PRELIMINARY ENGINEERING
IMX-080-3(315)128--02-77
POLK COUNTY

PLANS OF PROPOSED IMPROVEMENT ON THE
PRIMARY ROAD SYSTEM
POLK COUNTY
PRELIMINARY ENGINEERING

I-35/80 from IA 141 in Urbandale to E of I-35/80/235
 Northeast Mixmaster System Interchange (NEMM)

FIELD EXAM CHECKLIST

PROPOSED DSU
SIGNING AND ITS
MAINLINE I-35/80

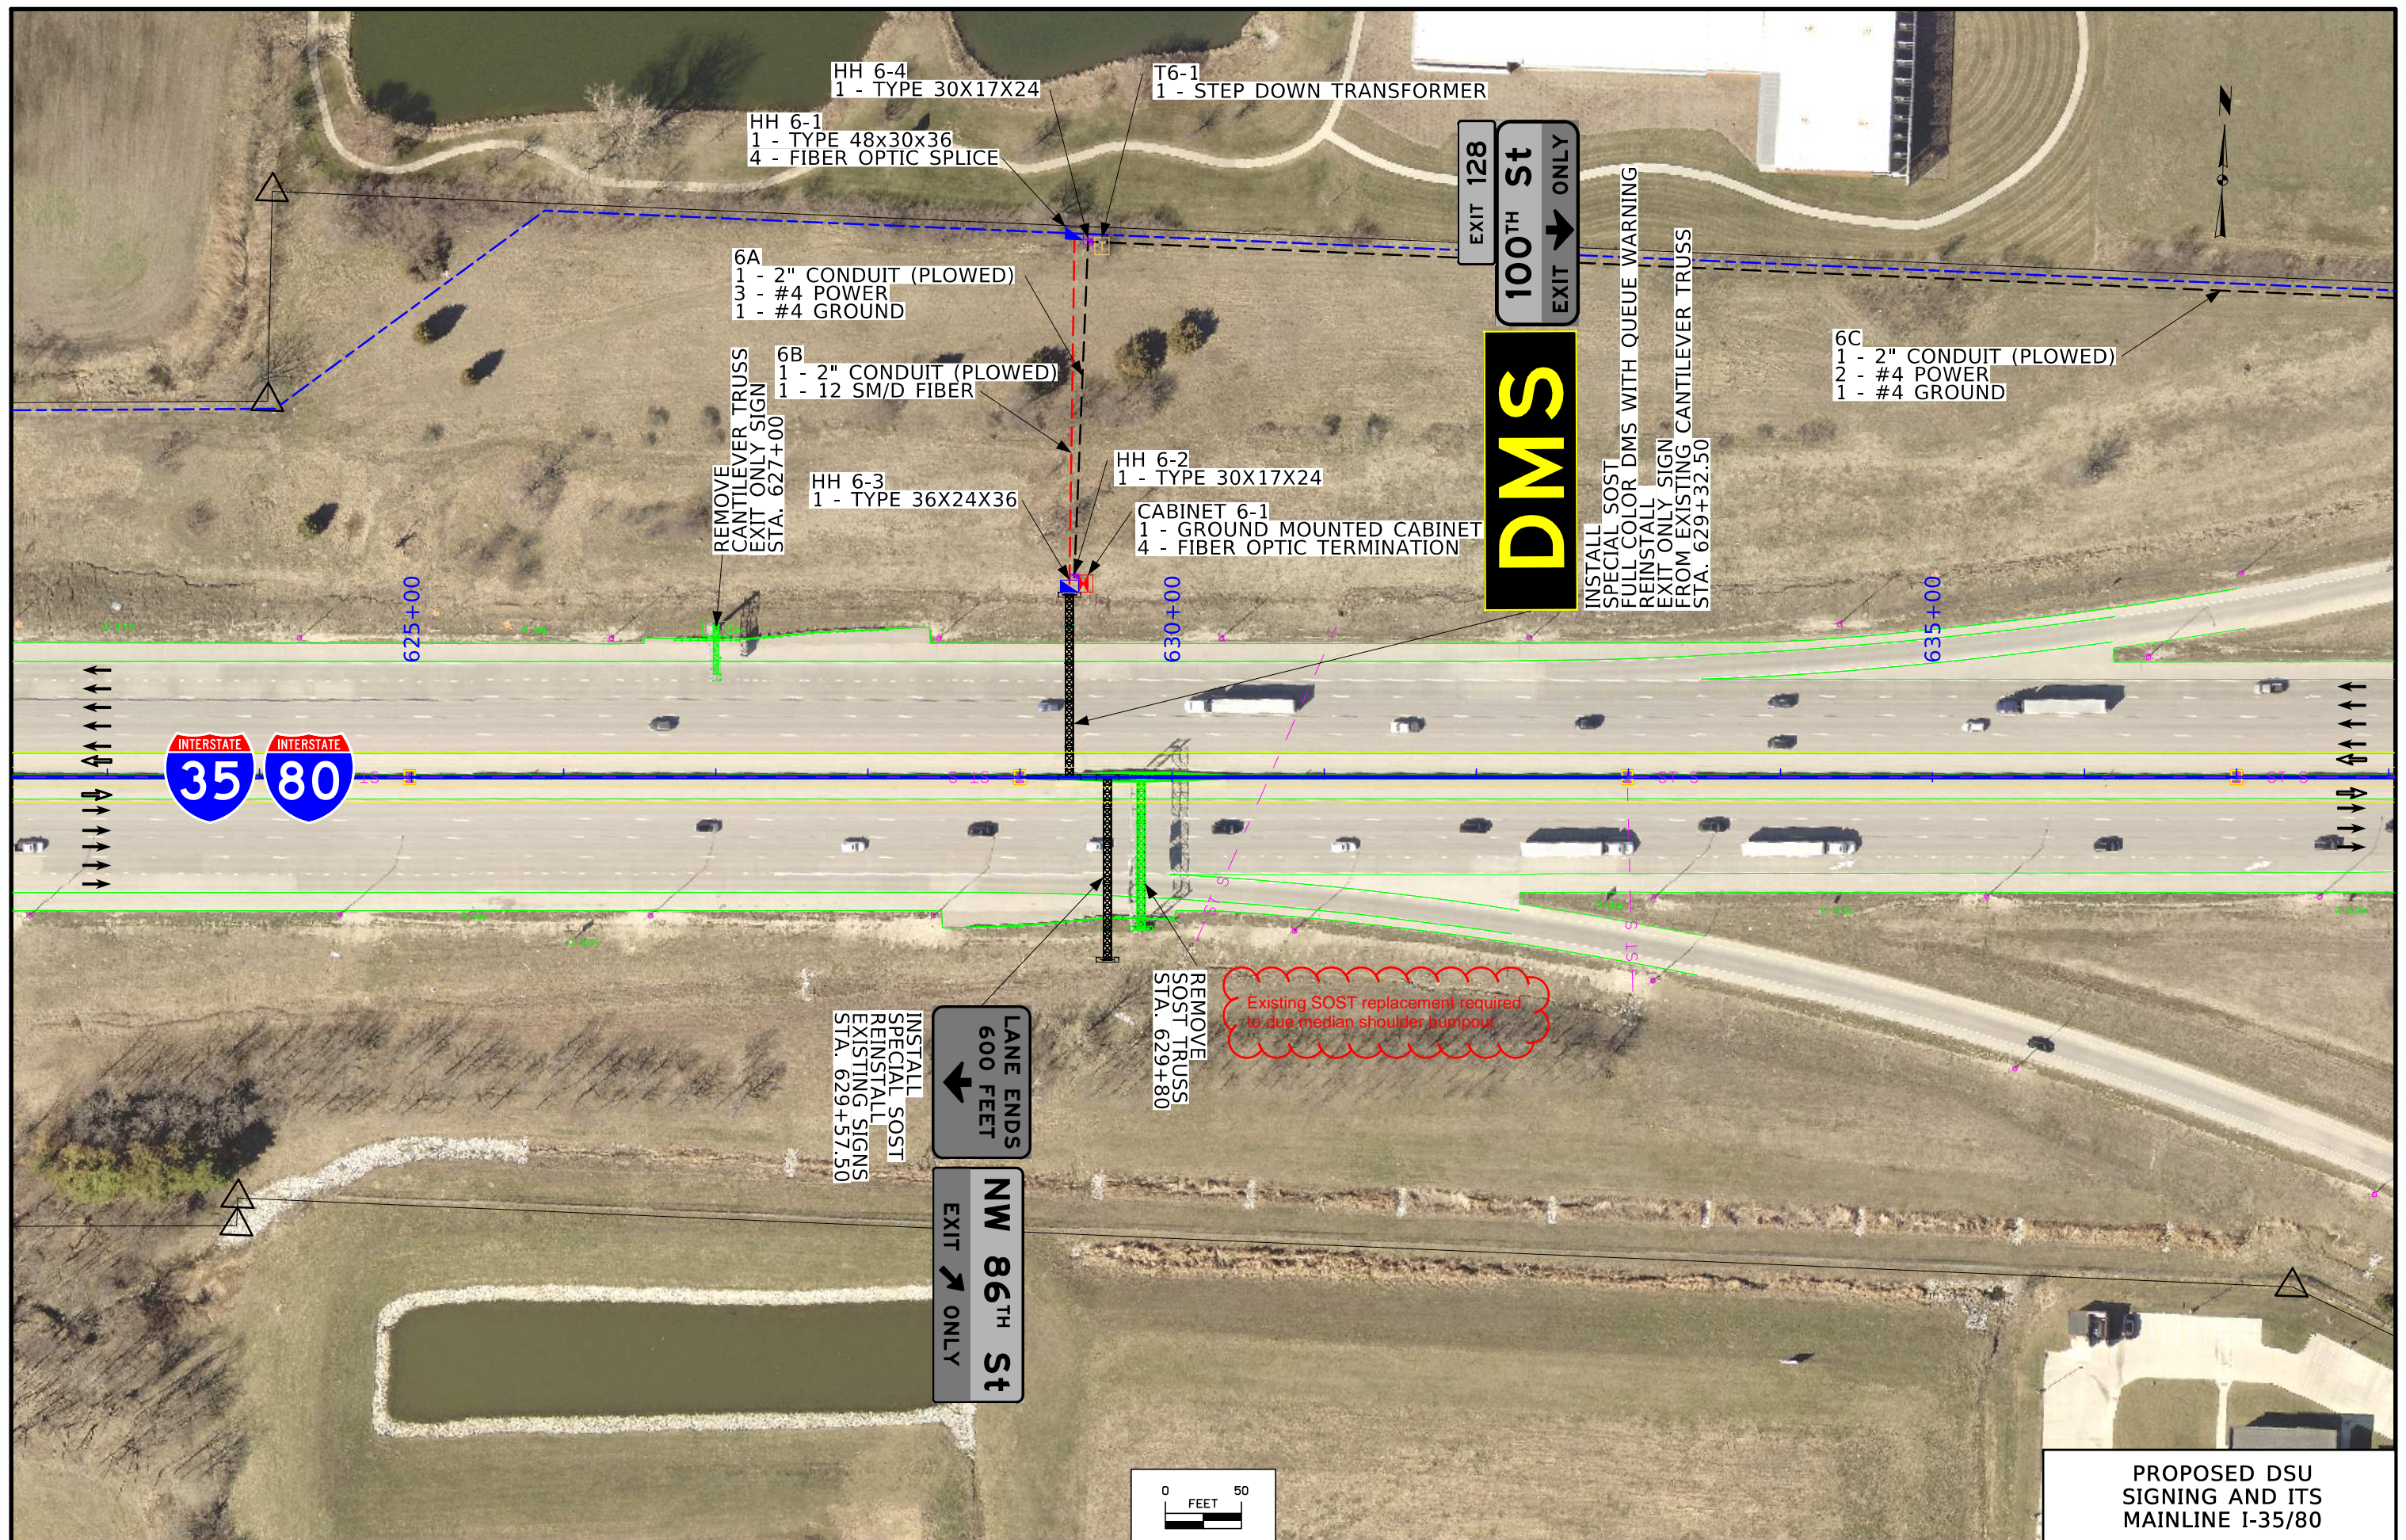
Existing SOST replacement required to due median shoulder bumpout

PROPOSED DSU
SIGNING AND ITS
MAINLINE I-35/80

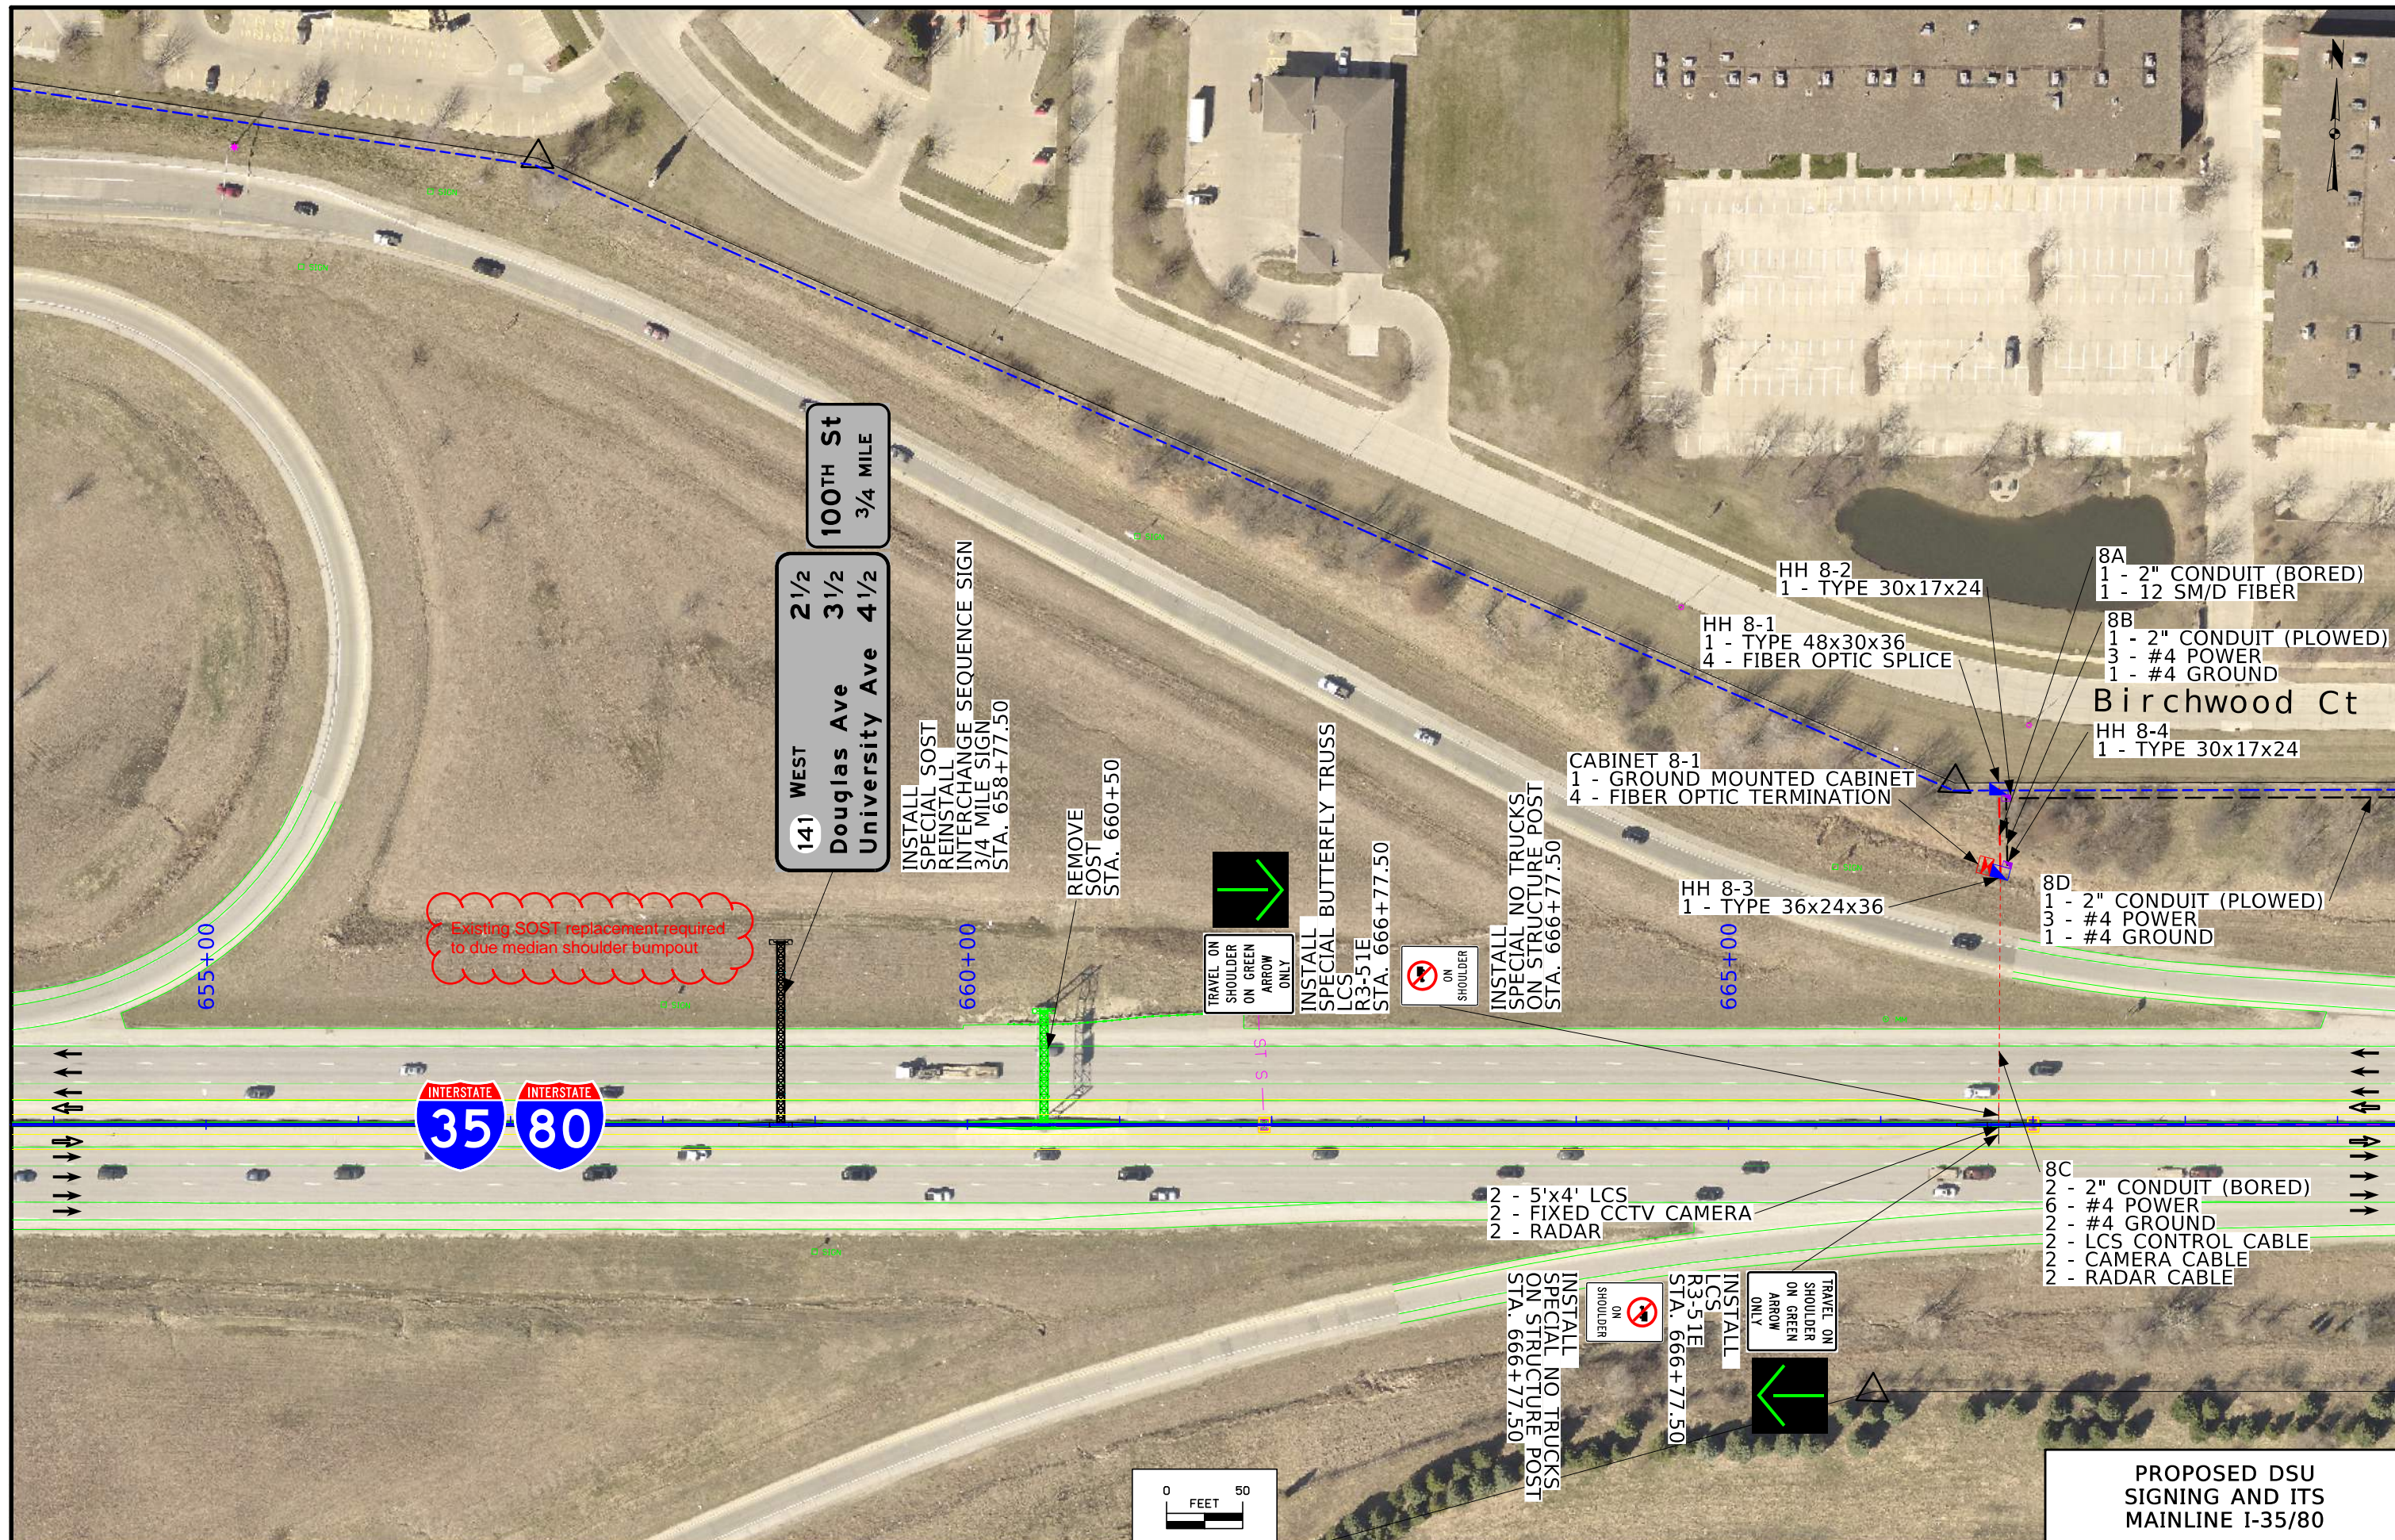
Existing SOST replacement required to due median shoulder bumpout

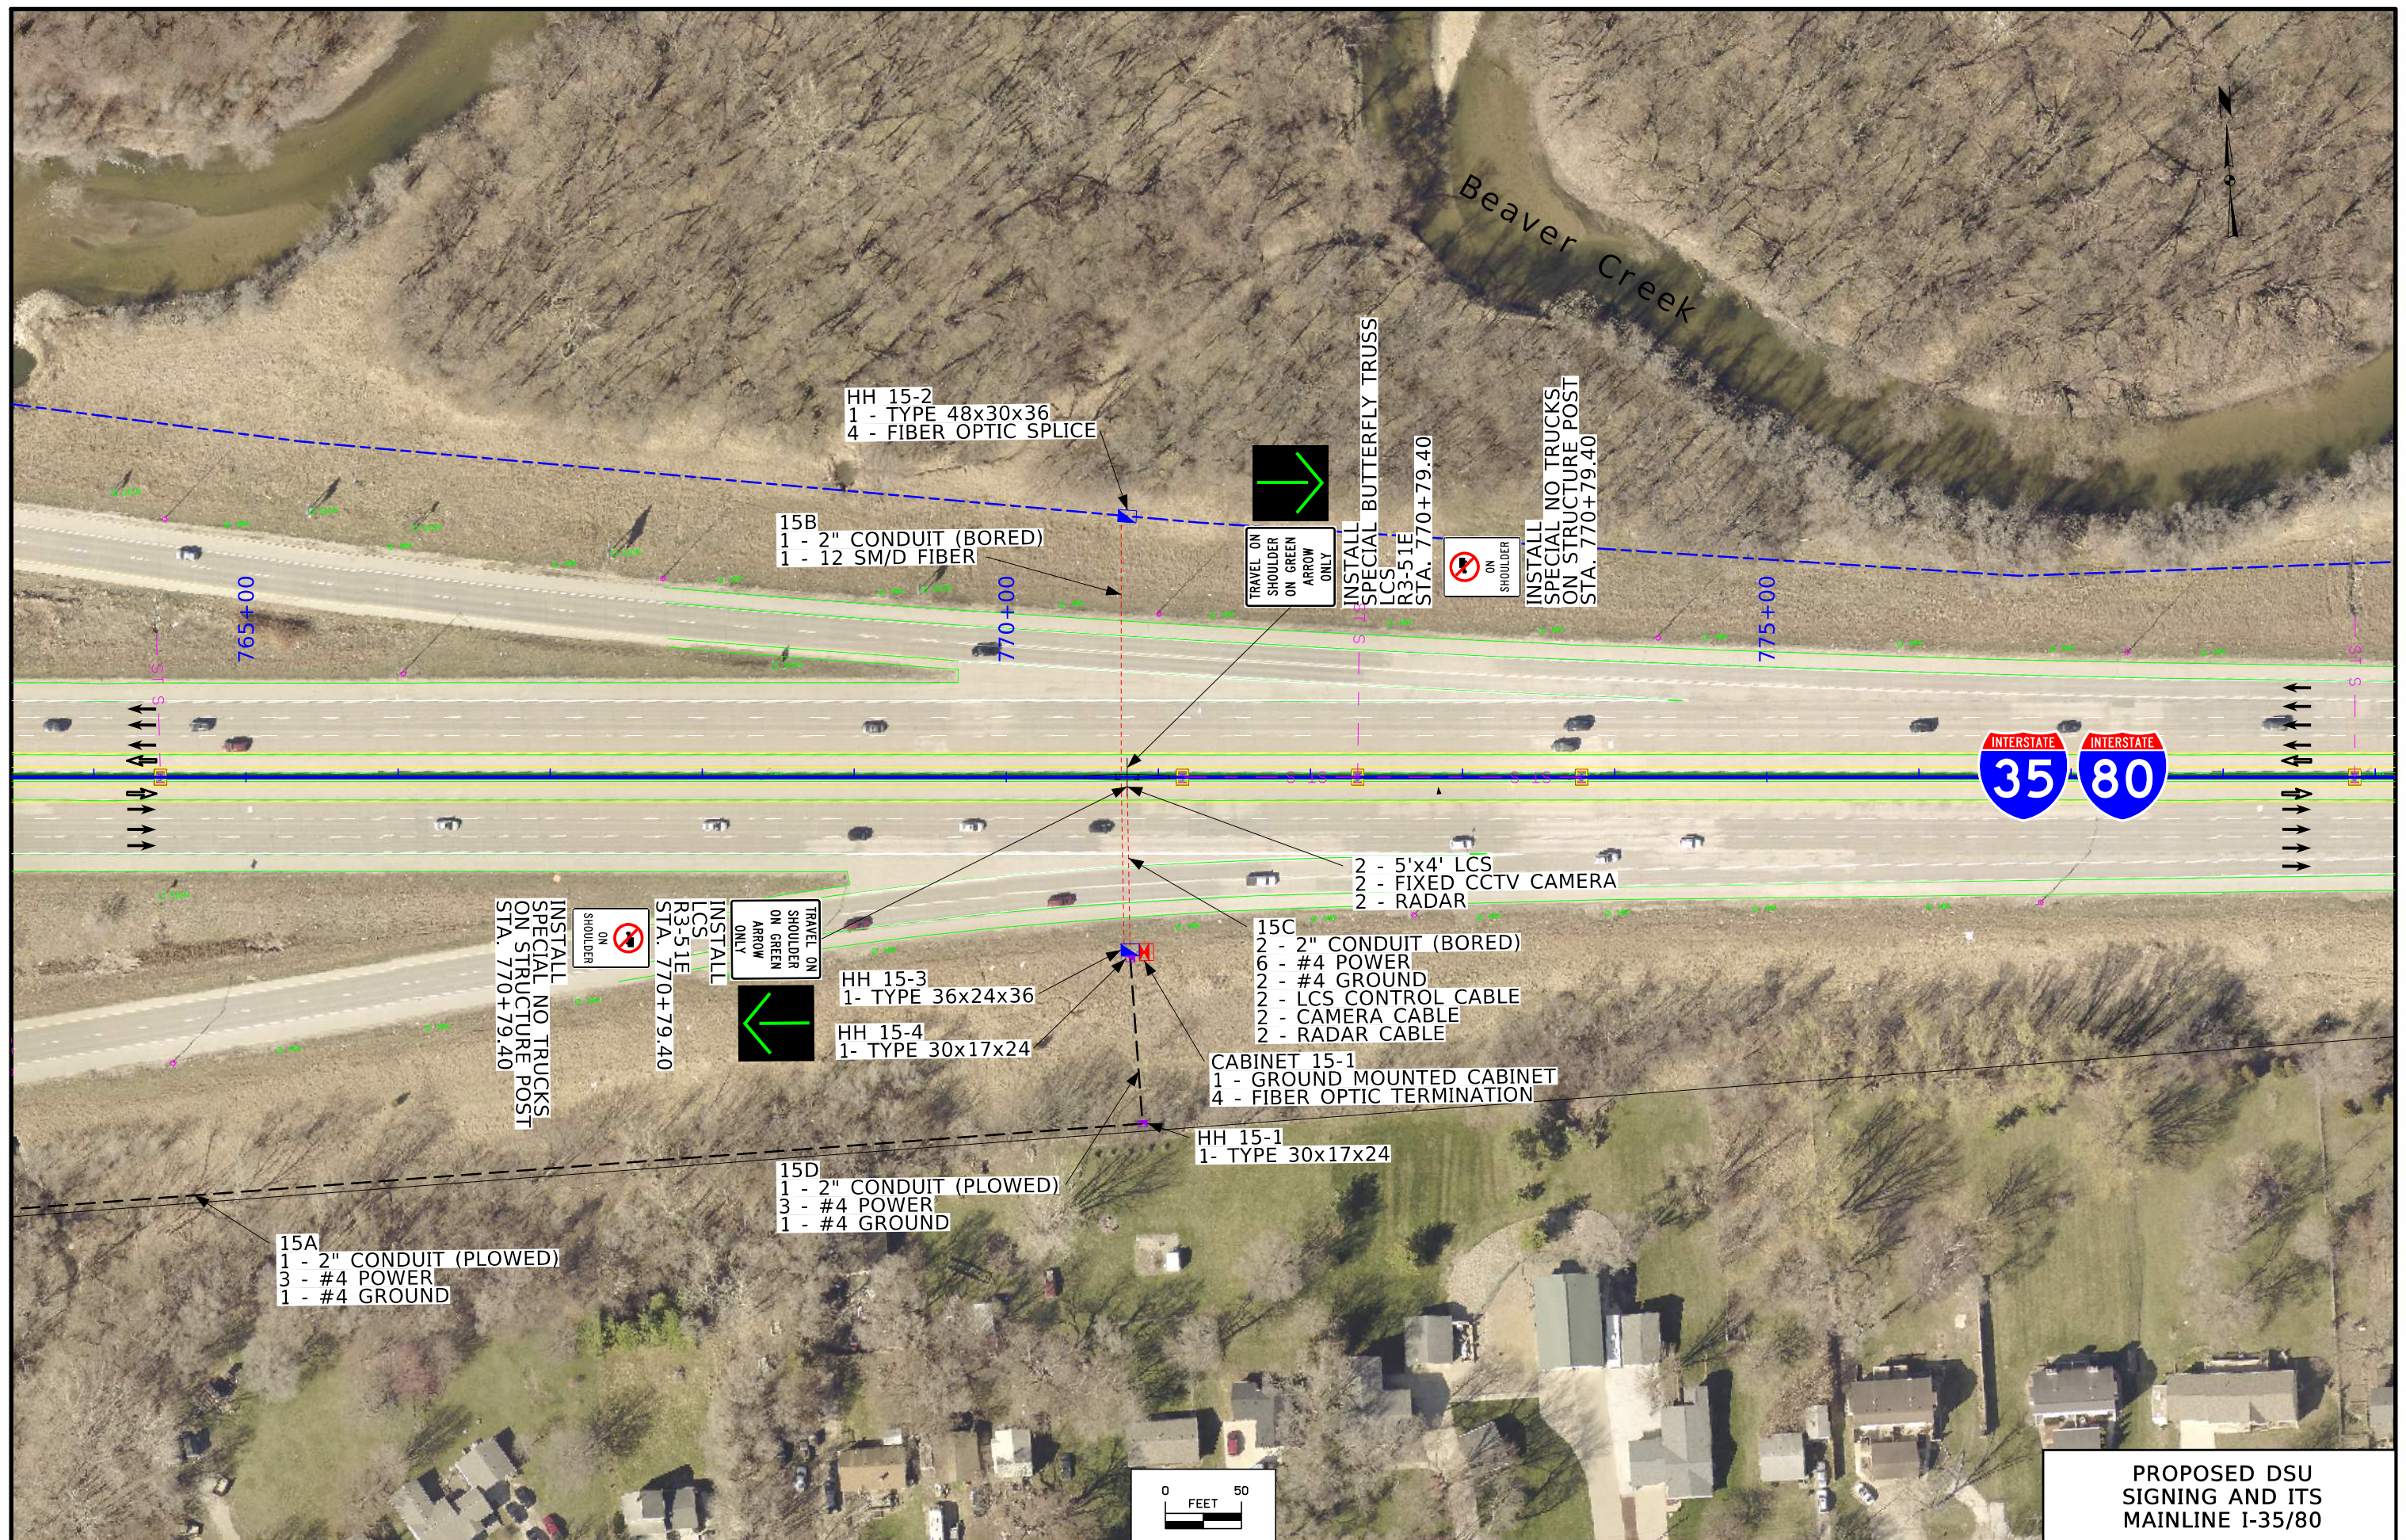
Option to maintain existing truss (not an existing conflict to maintaining 3' shy). Confirm if preference is to replace existing truss for corridor consistency and to accommodate future 5 lane section.
